SERVICE BULLETIN

SUBARU CORPORATION
Customer Quality Dept.
Japan.

Issued: Feb. 23, 2023

Subject:	Part Change Information: New Part GLASS-FRONT DOOR,PARTITION,RIGHT/LEFT as countermeasure against wind noise problem on BRZ
Applicable Section in Service Manual:	Body & Electrical/WIRING SYSTEM > GLASS/WINDOWS/MIRRORS > Front Door Glass
Applicable Parts Name in Parts System:	Door, Seat, Windshield and Instrument Panel > DOOR PARTS (GLASS & REGULATOR) > GLASS-FRONT DOOR,PARTITION,RIGHT/LEFT
Foreword:	This Service Bulletin is to inform you of the new GLASS-FRONT DOOR, PARTITION,RIGHT/LEFT as countermeasure parts against the wind noise problem that comes from front door partition glass area.

Test Procedure

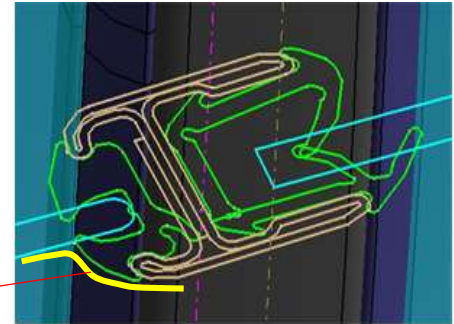
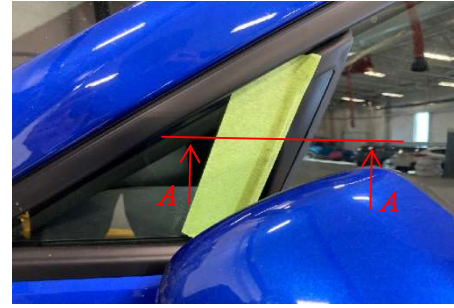
- Put a masking tape on the partition glass and the glass run channel as shown in the photo.
- Drive the vehicle and check if the noise is gone.
- If the noise is still there, noise source is not partition glass or glass run channel. Diagnose the other source.
- If the noise is gone, the source of the noise is the excessive clearance between partition glass and glass run channel.
Replace GLASS-FRONT DOOR, PARTITION, RIGHT and/or LEFT with the countermeasure one(s).
(Replace the part on the noisy side only.
No need to replace the no noise side.)

Masking Tape

Section A-A
